RESPONSES TO THE
U.S. NUCLEAR REGULATORY COMMISSION
REQUEST FOR ADDITIONAL INFORMATION
ON THE WEST VALLEY DEMONSTRATION PROJECT
PHASE 1 DECOMMISSIONING PLAN

GROUP 1 RESPONSES

August 14, 2009

U.S. Department of Energy
West Valley, New York

Figure F-2. Leachate Transfer Line Routing From NDA to Lagoon 1 (based on drawing 40C-S-1057)

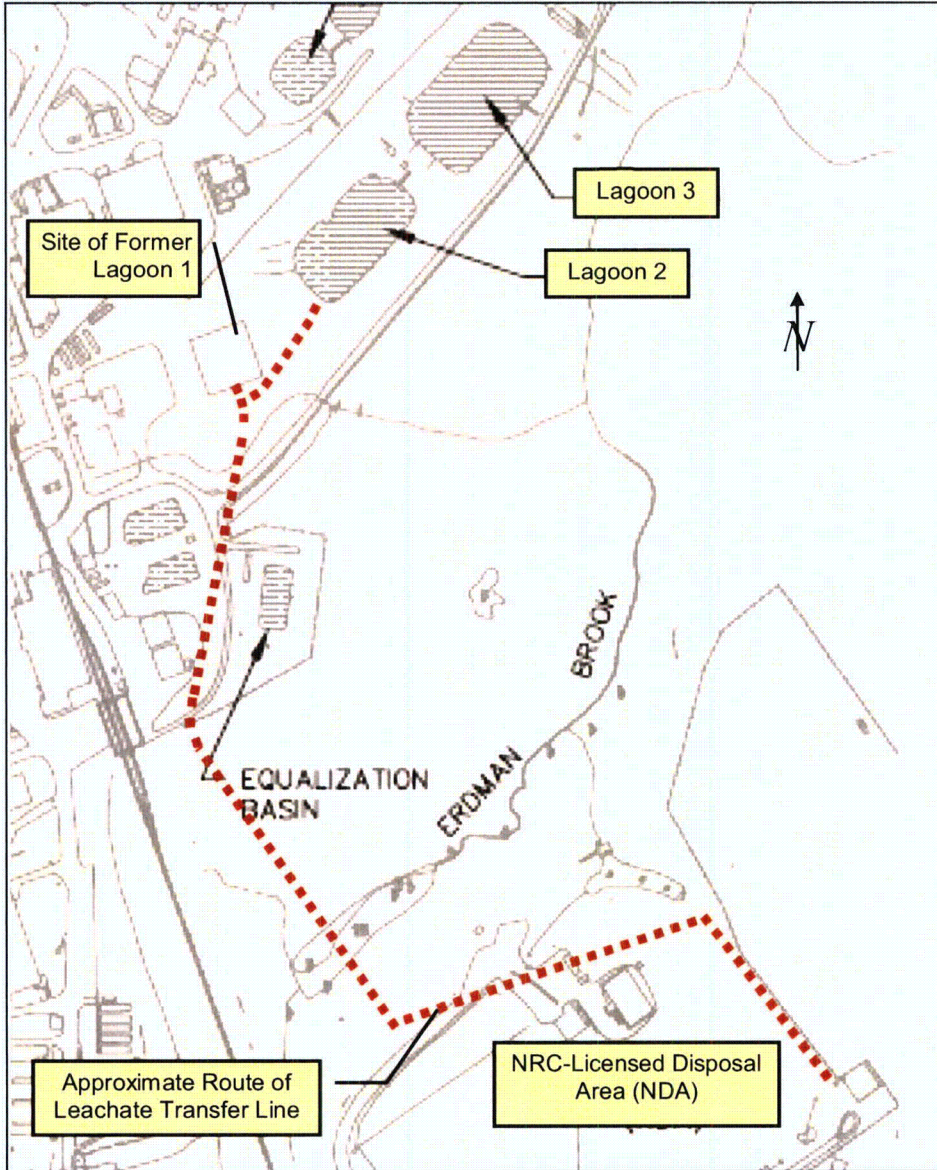
Basis: The figures (such as Figure 2-3) in the Decommissioning Plan (DP) provide current and previous locations of radionuclides, but do not clearly show the locations, depths, and distributions of piping that will be removed as part of the Phase 1 DP. The description on page ES-8 identifies underground piping generally, but does not provide a complete description of the likely distribution and magnitude of activity, or how the piping inventory estimates were developed.

Path Forward: Provide a description of the locations, depths and distributions of piping as well as estimated radiological inventory associated with the piping.

DOE Response: DOE will include information on the underground lines in a new appendix to the DP. A copy of this appendix, which is based on the radioisotope inventory report (Luckett, et al. 2004), is attached.

The line was originally used to transfer fluids originating from the SDA Lagoons to Lagoon 1 in the LLWTF via a pumphouse adjacent to the NDA hardstand. More recently, it has been used to transfer groundwater from the NDA interceptor trench to Lagoon 2. The total length of the line is approximately 2,000 feet. The location of the Leachate Transfer Line is shown on Drawing 40C-S-1057, on which Figure F-2 is based.

Figure 7-6. Conceptual Layout of WMA 1 Excavation (Showing underground structures and underground lines.)

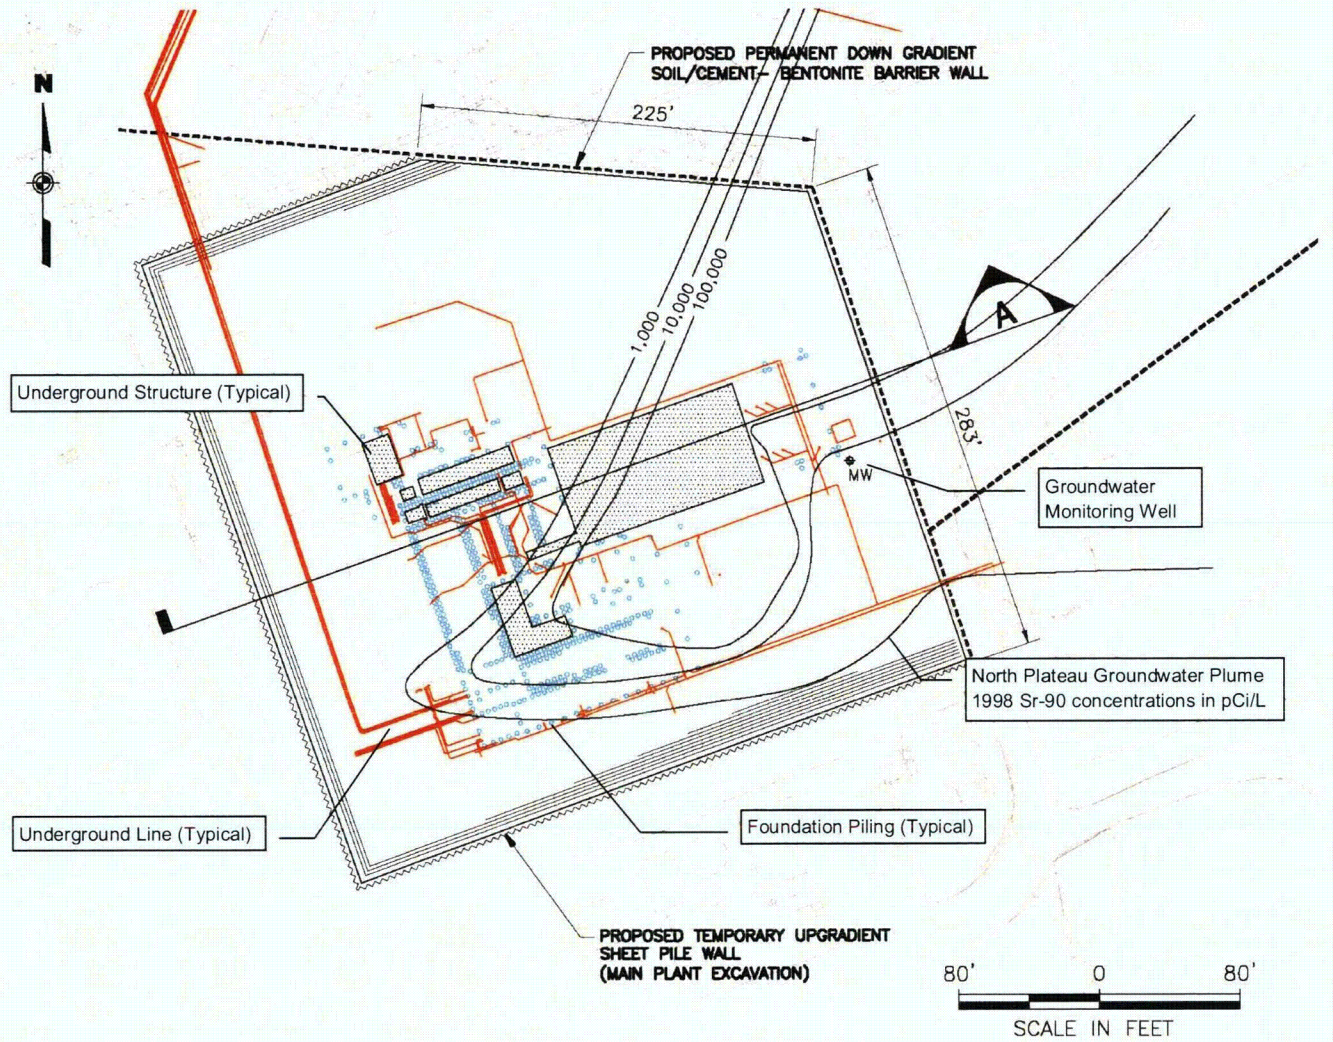
NRC Path Forward: Provide a description of the areal and vertical extent of sampling for contamination that has been completed associated with the H-piles and other discrete engineered features relative to past major spills, leaks, or known large sources of activity.

Figures 7-6 and 7-8 will be replaced with the figures shown on the following two pages, which show the pilings and better show the underground lines.

Figure 5C6-1 Recreationist Conceptual Model Cross Section

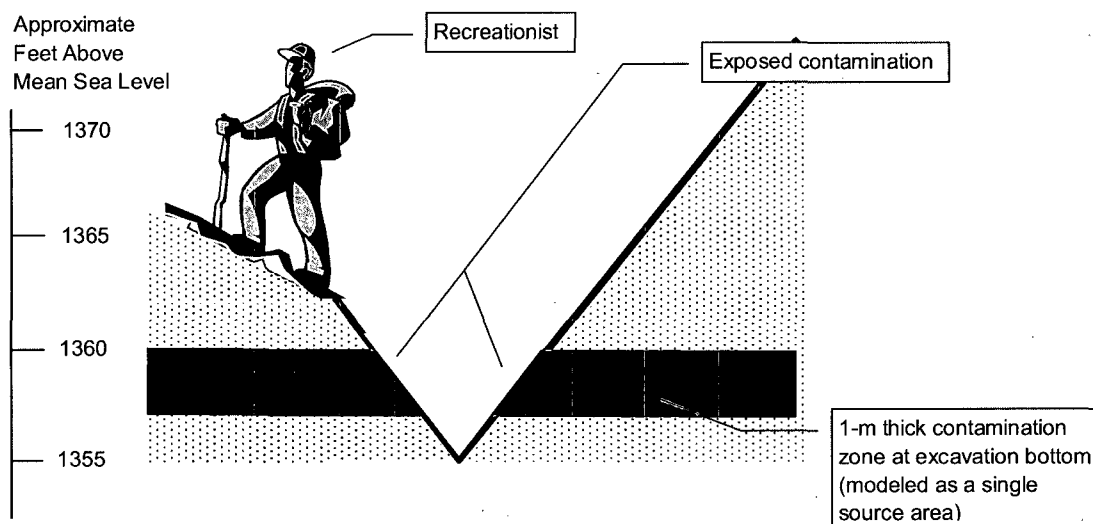
RAI: DOE did not provide enough information to show that the subsurface DCGL calculations considering a cistern drilling scenario are bounding. (Section 5.1.4, Page 5-14)

DOE acknowledges that gully erosion could intrude upon the lagoon areas (see page 5-14). However, DOE did not provide quantitative support for its assumption that erosion from gully formation/advancement, or stream widening could intercept the WMA 2 source areas and produce greater exposures to an offsite or onsite receptor.

Path Forward: DOE should provide the results of a quantitative analysis that supports its assumption that the subsurface DCGLs calculated assuming a cistern driller scenario bound the potential impacts from erosion.

A plausible scenario for these conditions would involve a recreationist spending time hiking in the area, which is assumed to be rent by deep gullies that extend to the bottom of the WMA 2 excavation. Figure 5C6-1 illustrates the basic conceptual model. This scenario was analyzed using RESRAD in the deterministic mode with the following key conceptual model input parameters:

- The exposed contamination zone area in the gully walls is assumed to be two meters wide and 100 meters long, a reasonable size to represent the likely geometry of the exposed contamination in the gully (modeling a single source area rather than the two illustrated in Figure 5C6-1 was more practical);

The modeling of this recreationist scenario produced DCGLs for 25 mrem per year that were more than one order of magnitude greater than the DCGLs produced with the cistern scenario for all 18 radionuclides of interest. These results demonstrate that the cistern scenario is more limiting for an onsite receptor.

Figure 5C8-1. Conceptual Model

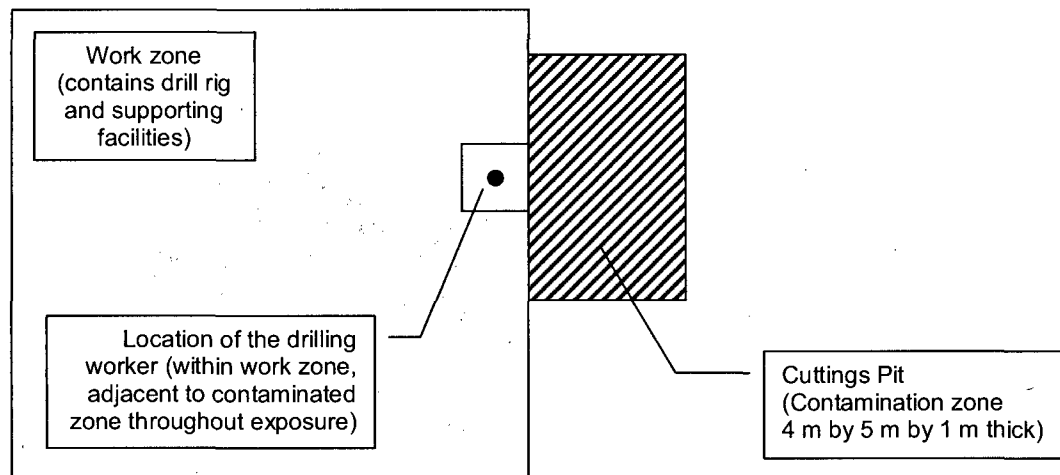
Basis: The approach of using a scenario where a cistern well is installed and a resident is exposed to the contaminated cuttings may be limiting for some types and distributions of contamination, but may not be limiting for certain sources. For example, the old sewage plant drainage was significantly contaminated and covered with three feet of soil. While the old sewage plant drainage is not considered part of the scope of Phase 1 (see Figure 1-5), if contamination is located in a thin lens but in a hydrologically active or previously hydrologically active area to be remediated as part of Phase 1, the dilution and partitioning with soil afforded in the cistern disruption scenario may be larger and result in higher DCGLs than would be developed from exposure to contaminated groundwater or an excavation scenario that would become applicable if the cover was eroded.

- The excavated material is placed in a cuttings pit near the well, with the contamination zone at the surface consisting of rectangular area five meters by four meters by one meter deep;
- The well is drilled from a concrete pad, with the drilling worker located immediately adjacent to the pad;
- The drilling worker is present onsite for approximately 50 days (approximately 10 weeks) for 10 hours each day; and
- The drilling worker is exposed via inadvertent soil ingestion, inhalation of dust, and external exposure to ionizing radiation.

Figure 5C8-1 illustrates the conceptual model geometry

The calculations were executed utilizing RESRAD version 6.4 in the deterministic mode. DCGLs were developed based on a dose limit of 25 mrem per year, with the dose-to-source ratios and the DCGLs adjusted to account for dilution of contaminated material with clean material excavated, with the Cs-137 and Sr-90 DCGL's being adjusted to account for decay during the 30-year institutional control period.
